City of Alameda

Staff Report

File Number:2017-3803

PLN15-0232 - 1208 St. Charles Street - Applicant: Paula Mathis and Tom Ellerbe. The Planning Board will hold a Public Hearing to consider Design Review for a project consisting of the demolition of a two car garage and the construction of an accessory structure that will have a three car garage and an artist studio. The proposed accessory structure is approximately 880 square feet which is less than 40% of the required rear yard allowed for accessory structures per Alameda Municipal Code (AMC) Section 30-4.1(d).7. This project is categorically exempt from further environmental review pursuant to the California Environmental Quality Act (CEQA) Guidelines, Section 15303 - New Construction of Small Structures. (Continued from January 9, 2017)

Sheet Title: PROPOSED
SITE PLAN
ROOF PLAN
PROJECT DATA
NOTES

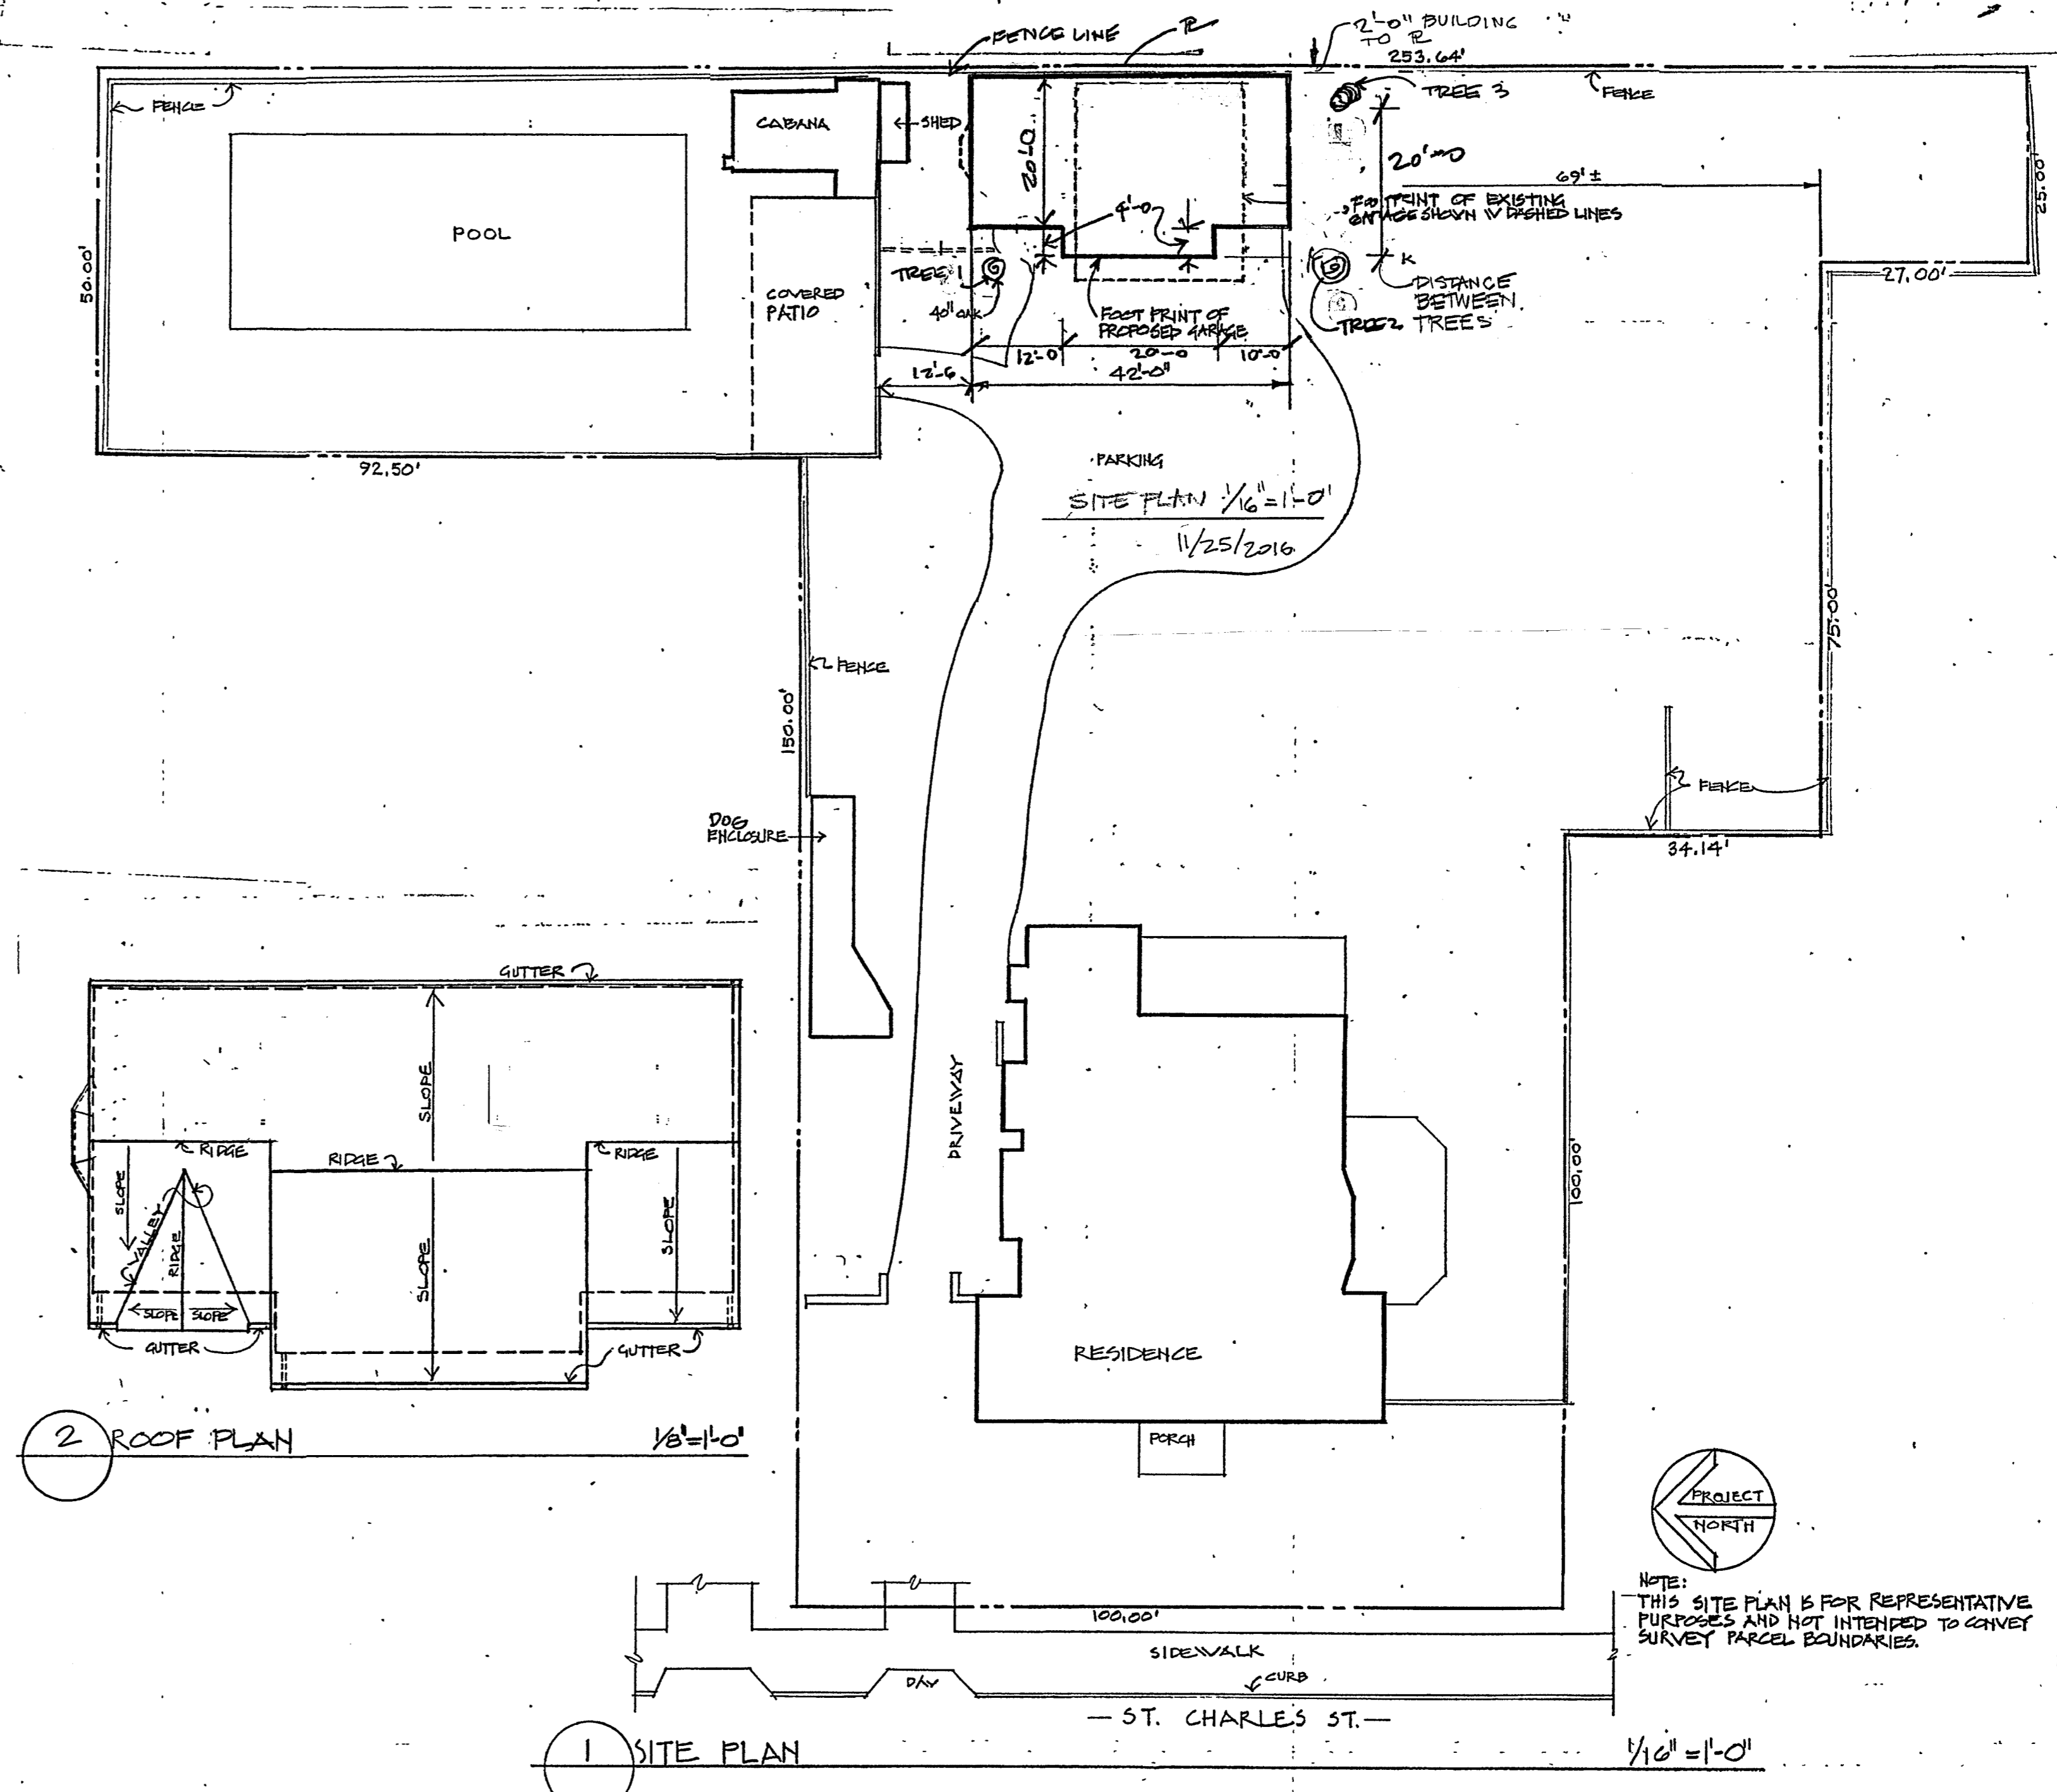
REVISIONS:
11/18/2016 DIM ADDED
11/23/2016 TREE NOTES ADDED, TREE # ADDED

The following precautions should be taken within the CRITICAL ROOT AREAS (CRA) of the 3 protected trees labeled as Tree #1, #2 and #3 on these plans. The CRA is one foot of radius per inch of trunk diameter (DBH) measured at 4" above the ground. For example, if a tree's DBH is 10", then its CRA is 10'.

- Wires, signs and ropes shall not be attached to any protected tree.
- Fill soil shall not be added to the CRA.
- If injury should occur to any protected tree during construction, the consulting arborist shall evaluate the injury right away, so that appropriate treatments can be applied. Any tree wounds should be cleaned up as soon as possible.

- Where surface grades are to be modified, water should always flow away from tree trunks, so that trunk bases are not at the lowest point. If the base of a tree's trunk is at a low point, a drain system should be designed with the least impact to the roots.

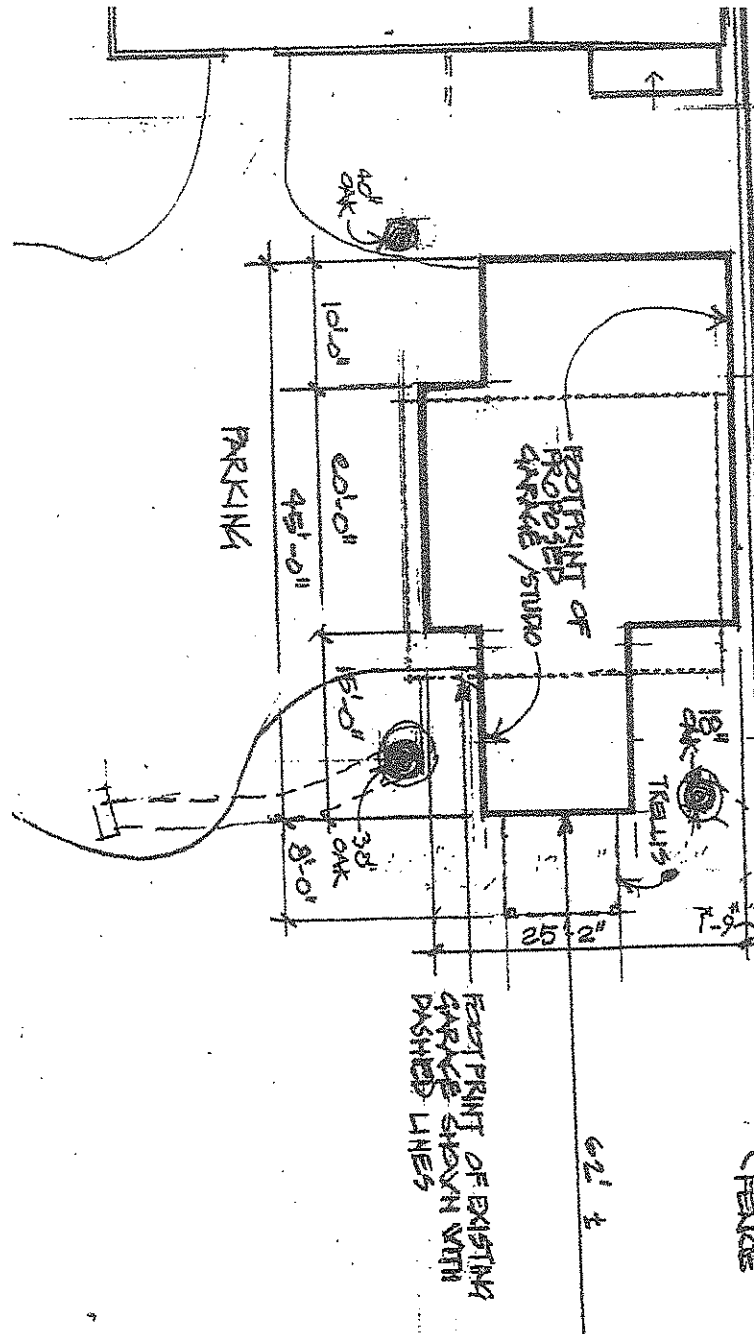
This site sketch pdf file, blown up from the drawing provided by you on 9/15/16, shows the solid lines of the proposed new garage relative to the three oaks that will require protection. Tree #1 is shown above, near the path to the swimming pool gate. Tree #2 is below on the left, near the paved area. The large lower limb on it, extending toward the house, is indicated with dashed lines. Tree #3 is below on the right, near the fence to the property.

1208
garage

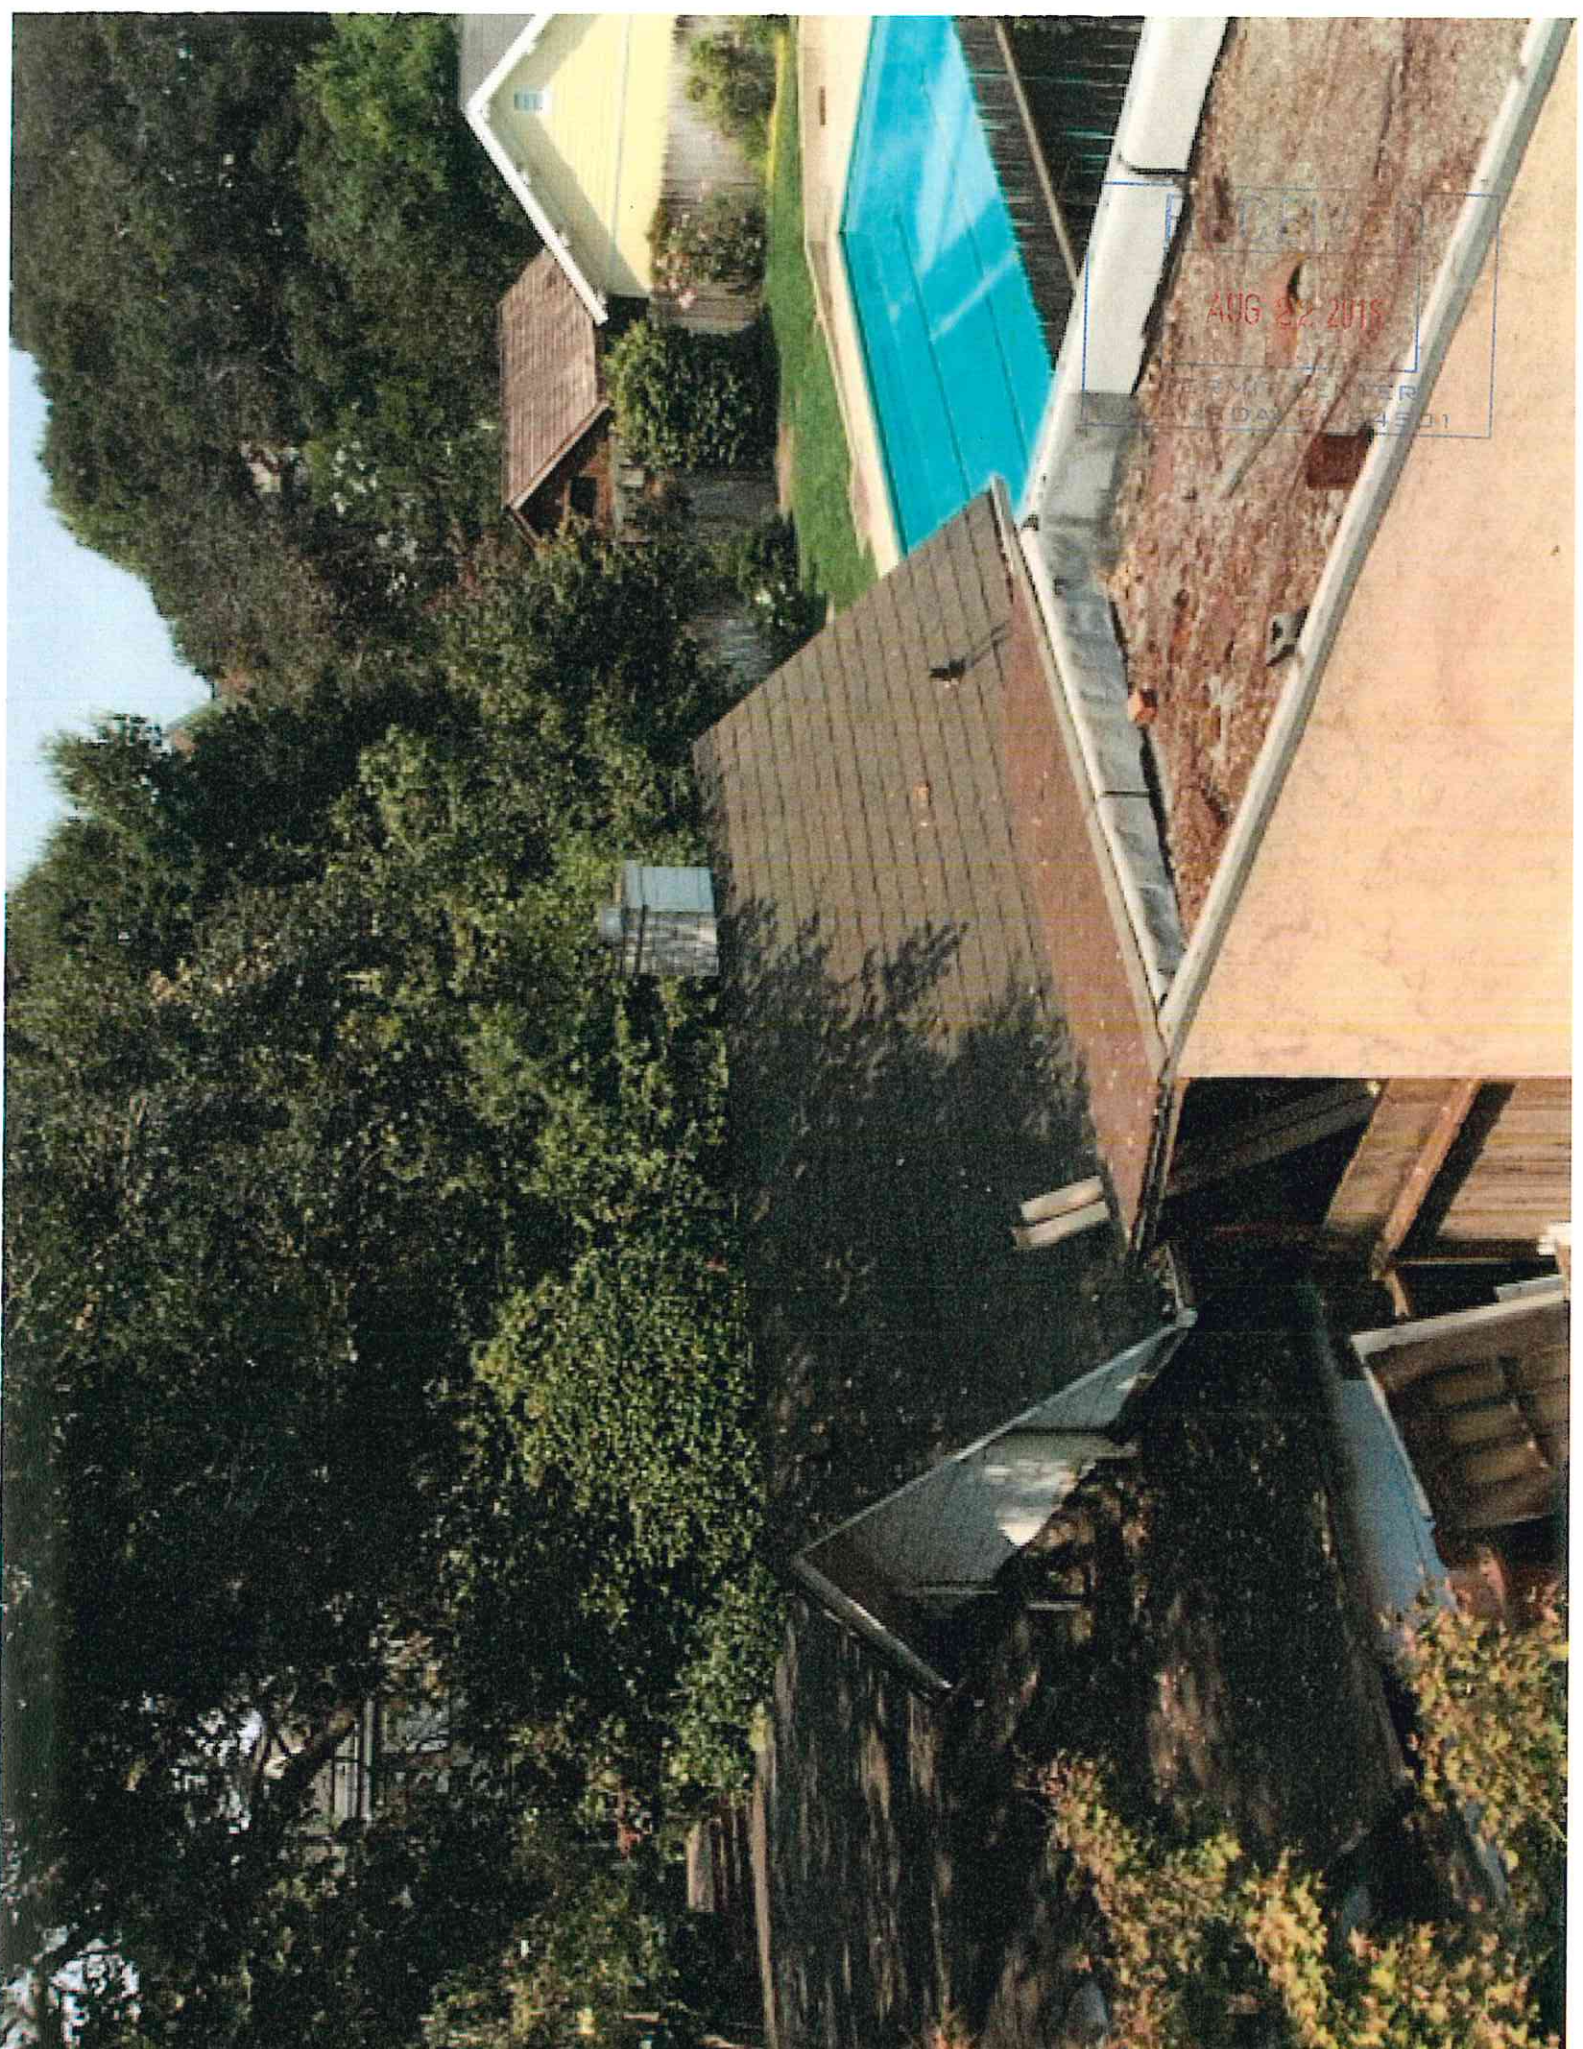
- 1) No specific plan has been submitted to address the drainage of water from the roof of the 920 sf Art Studio/3 Car Garage. The proposed structure would be less than 2 feet from the garage at 1143 Bay st. and 10 ft from the new construction at 1143 bay st.
- 2) The proposed plan does not address how access will be achieved to maintain gutters at the back of the structure.
- 3) No specific plan has been made to include a review of impact to the roots of Oak tree at 1208 St. Charles and Maple tree at 1143 Bay St. by the proposed structure.
